CHANGE ORDER #5: NEW RICE BRANCH LIBRARY PROJECT

PROPOSAL REQUEST 004

DESCRIPTION: Electrical Connections at Toilet Fixtures

Change Order

SKEL-2A

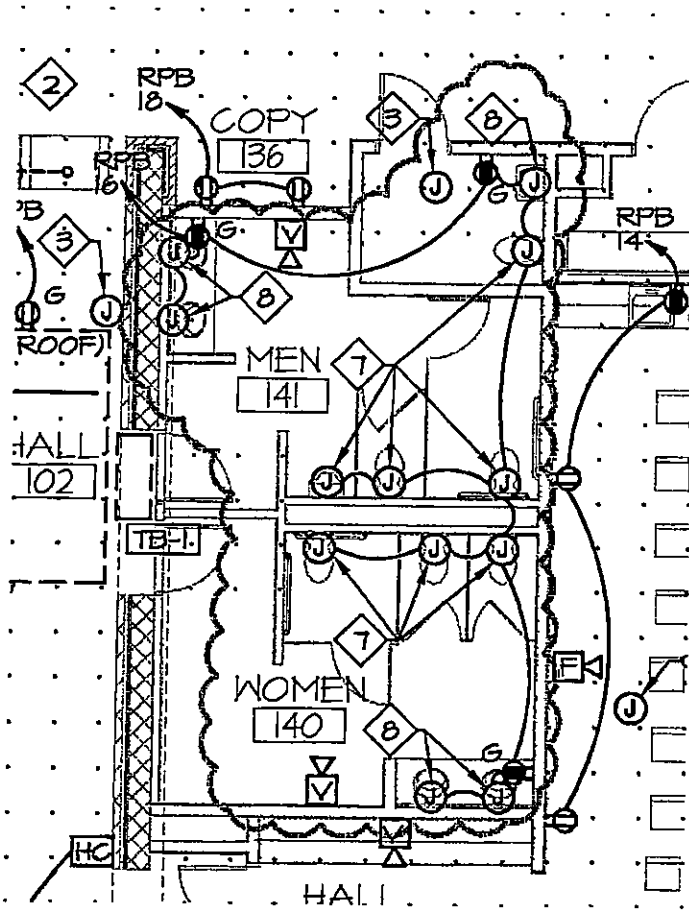
Provide costs associated with work outlined in the attached sketches. Also, provide costs associated with providing electric flush valves.

- 7 JUNCTION BOX FOR FLUSH VALVE - 120V.
- 8 JUNCTION BOX FOR AUTOMATIC FAUCET - 120V.
